**PREVOST**

**SAFETY  
RECALL**

**SR17-15**

DATE :	May 2017	SECTION :	18 BODY
SUBJECT:	FRONT SERVICE/ENTRANCE DOOR REFLECTORS

Figure 1

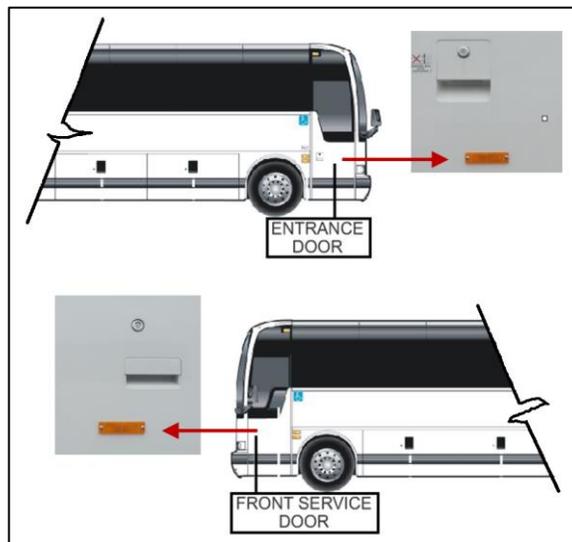
1. Check if all your vehicles (one or more) listed above have the reflector on the entrance door and on the front service door (Figure 1).
2. If the reflectors are already installed, bulletin is completed.  
If the reflectors are not installed, move to next step.

Figure 2

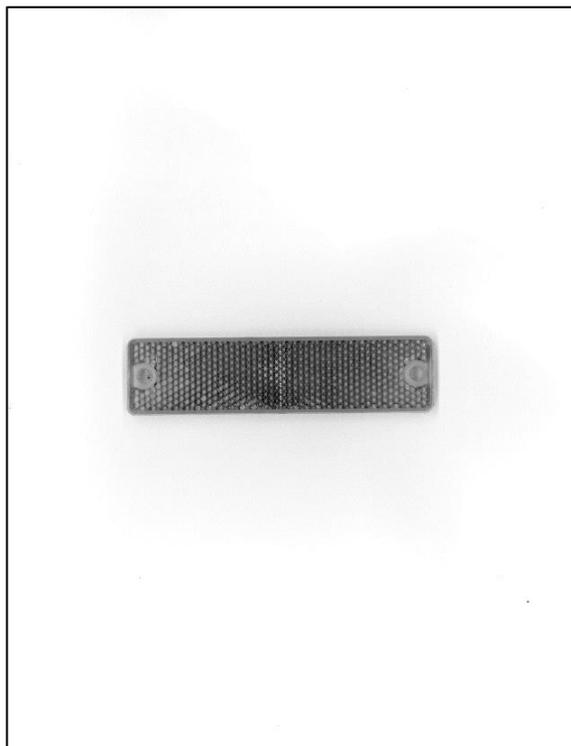
3. In order to make a template, use a copier machine and make a copy of the reflector, yellow side down.
4. Compare the size of the picture on the copy with the reflector Figure 2. If the scale on the picture matches with the reflector, you can use the copy as template to position the mounting holes on the door panel.
5. Use adhesive tape to install the copy on one door panel. For positioning dimensions, see Figure 3 for entrance door and Figure 4 for front service door. Make sure the apparent holes are at the same height to make the reflector final position horizontally.
6. Use a center punch and make two marks throughout the template apparent holes.
7. Remove the copy and drill two holes with a drill bit #29 (0.136"). The mounting screws are only 1/2" long, therefore, drill only throughout the first panel sheet.
8. Repeat steps 5 to 7 for the other door.

Figure 3

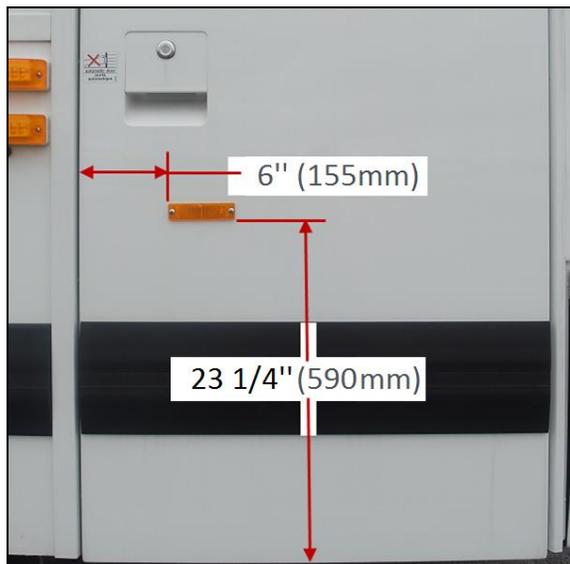
9. Clean the surface with anti-silicone.
10. Remove the protective backing paper on the reflector.
11. Insert screws into the reflector holes and use it as guide to position the reflector #930212 on the entrance door panel as shown on Figure 3.
12. Tighten the screws by hand using a screwdriver until the head makes contact with the reflector surface.

Figure 4

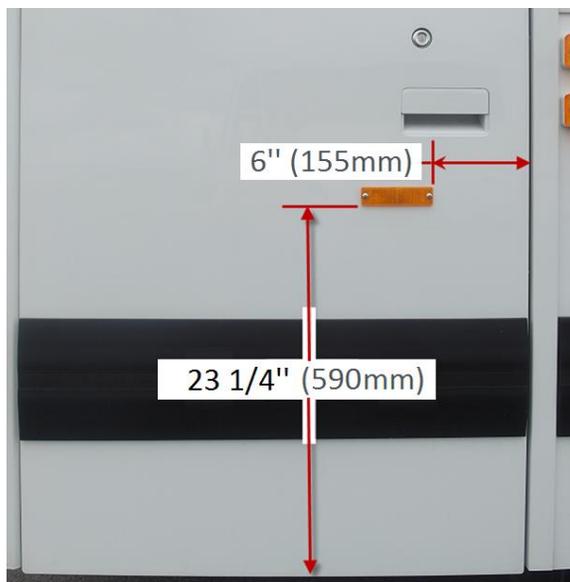
13. Clean the surface with anti-silicone.
14. Remove the protective backing paper on the reflector.
15. Insert screws into the reflector holes and use it as guide to position the reflector #930212 on the entrance door panel as shown on Figure 4.
16. Tighten the screws by hand using a screwdriver until the head makes contact to the reflector surface
17. Bulletin is completed.
